Enclosure 4
Marked-up Equipment Layout Drawings
for SQN Units 1 & 2
(2 pages)

SEQUOYAH NUCLEAR PLANT
 TENNESSEE VALLEY AUTHORITY

EQUIPMENT PLANS-ROOF

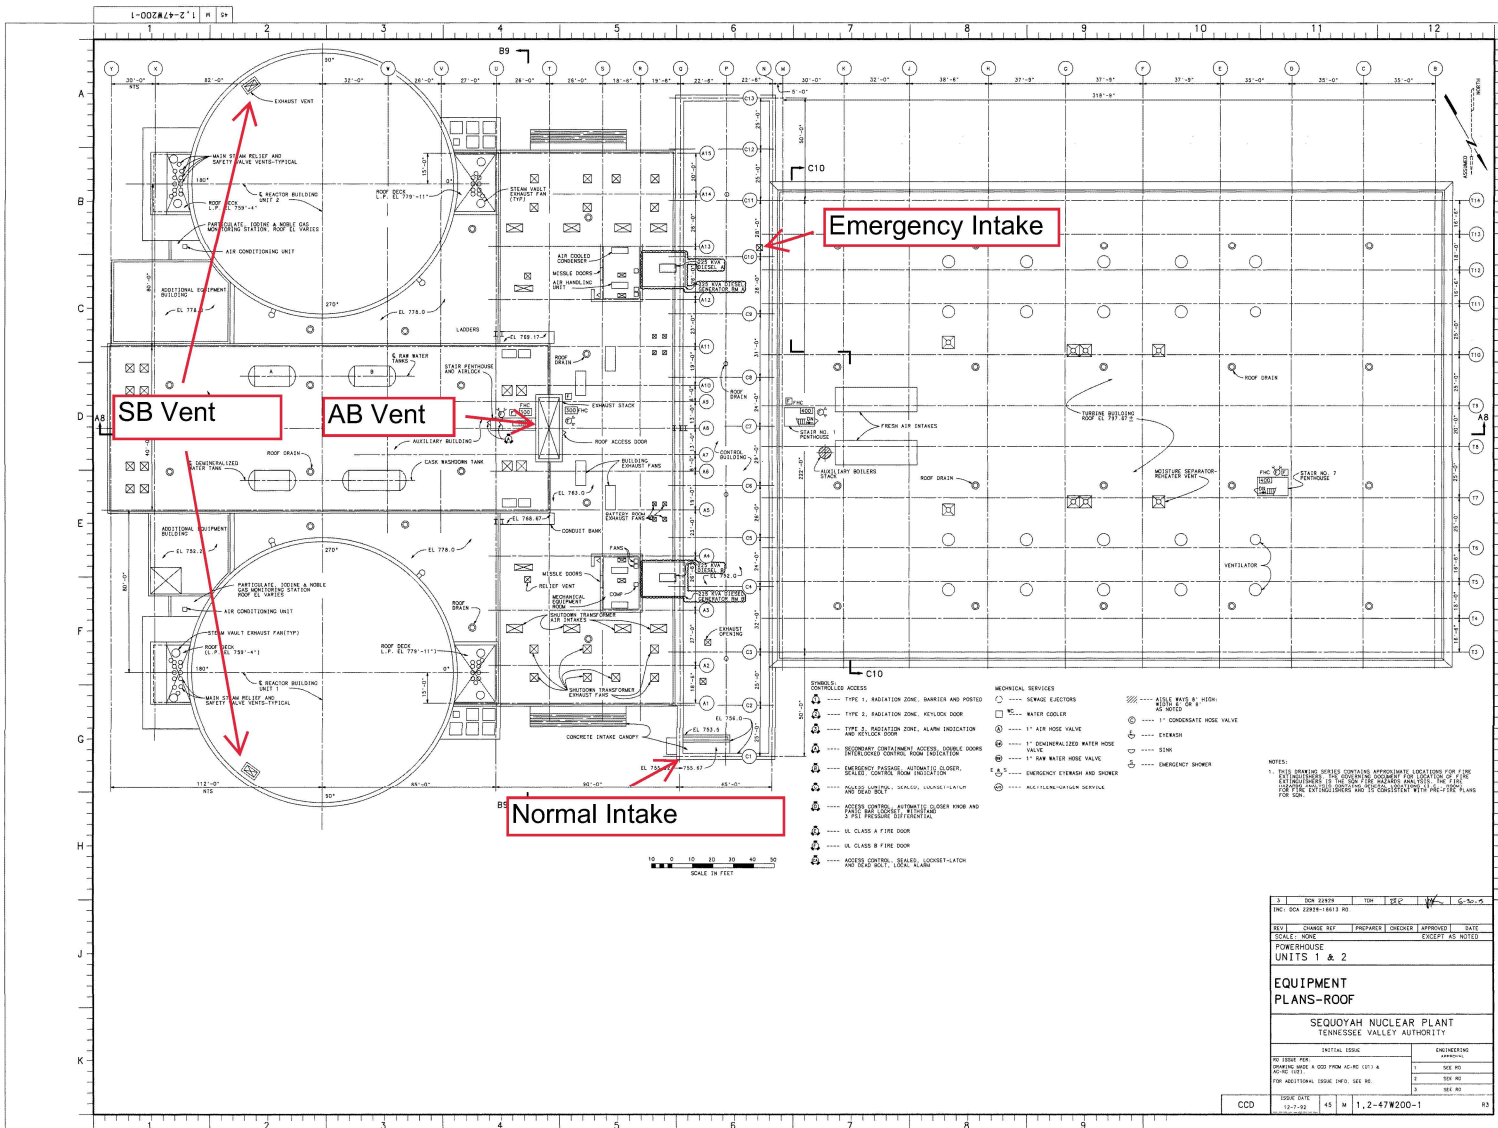
Emergency Intake

SB Vent

AB Vent

Normal Intake

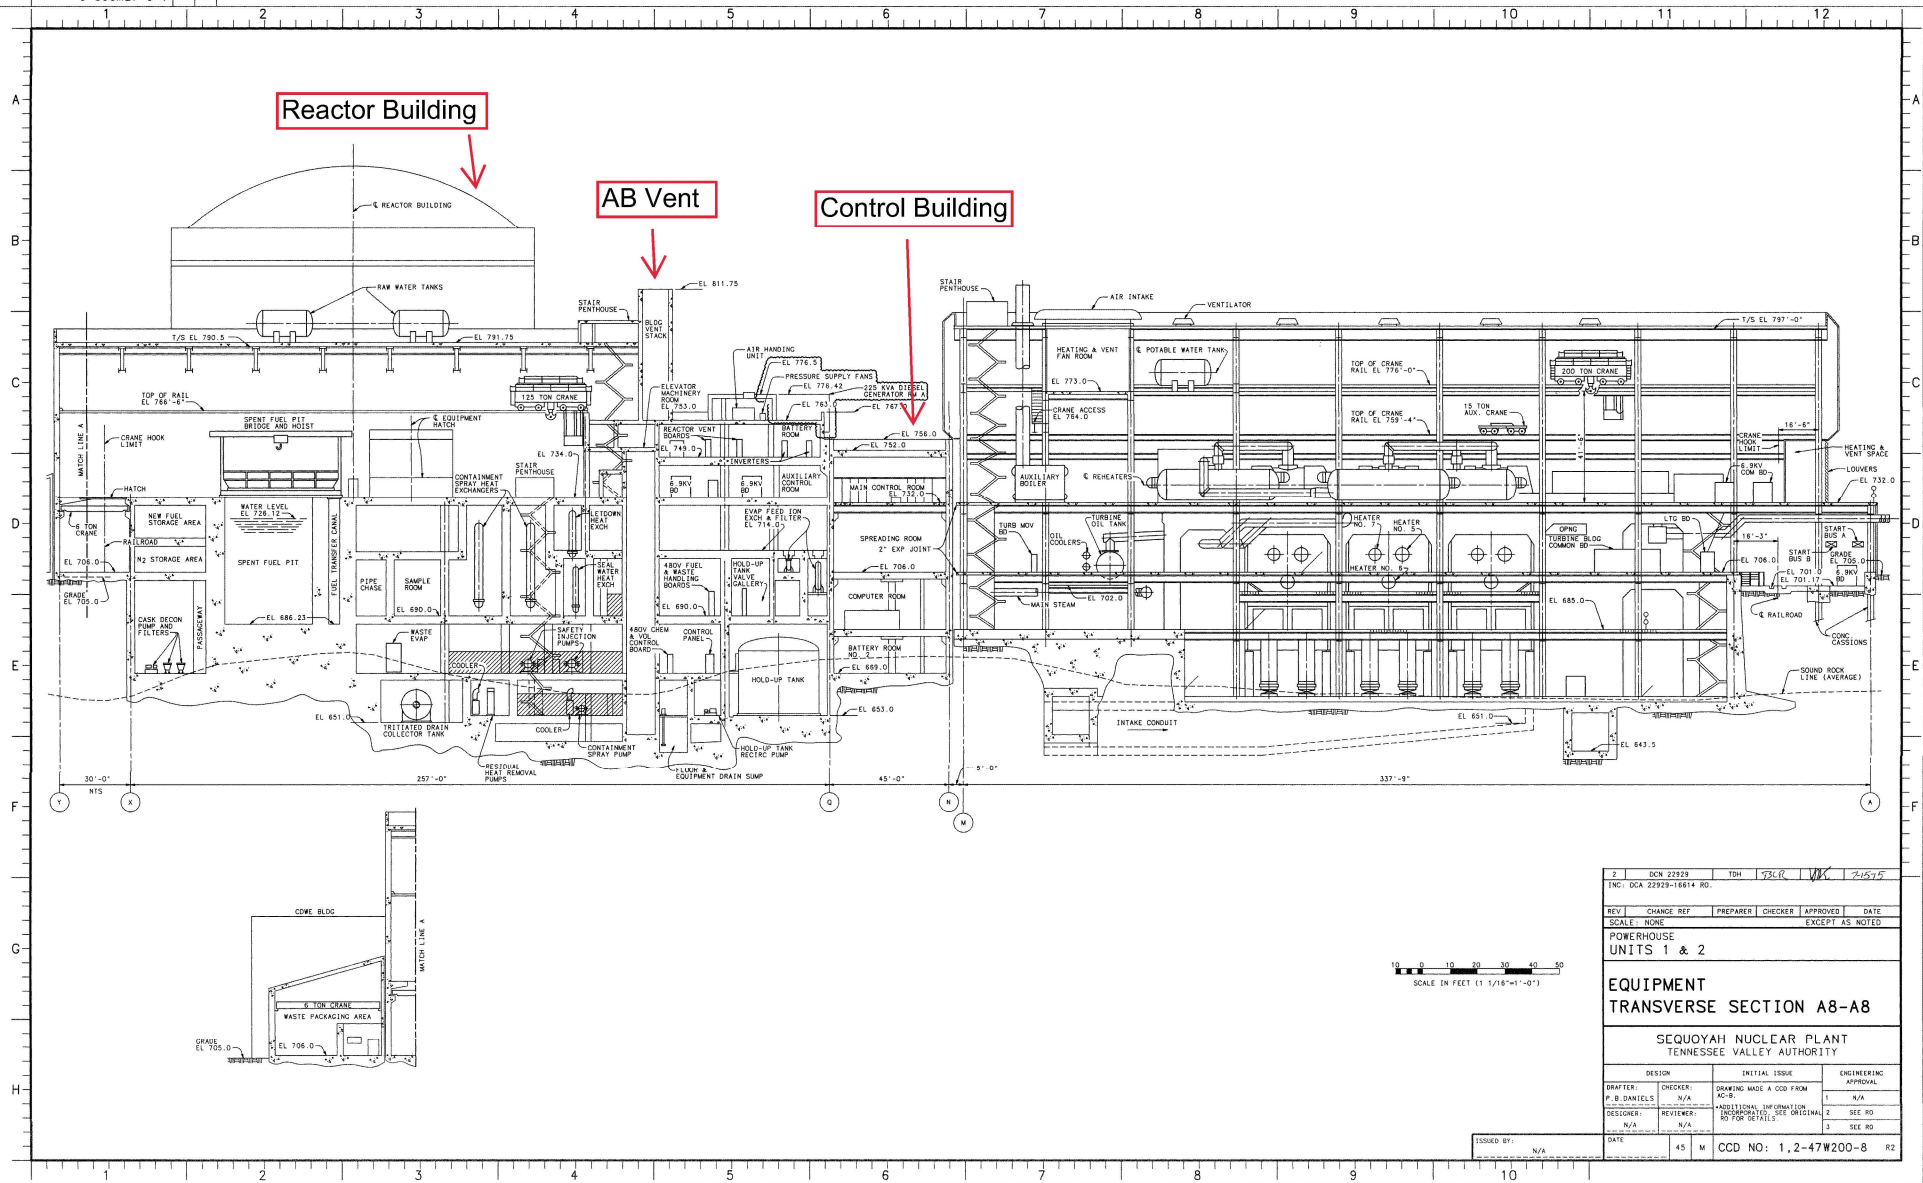
Reactor Building

AB Vent

Control Building
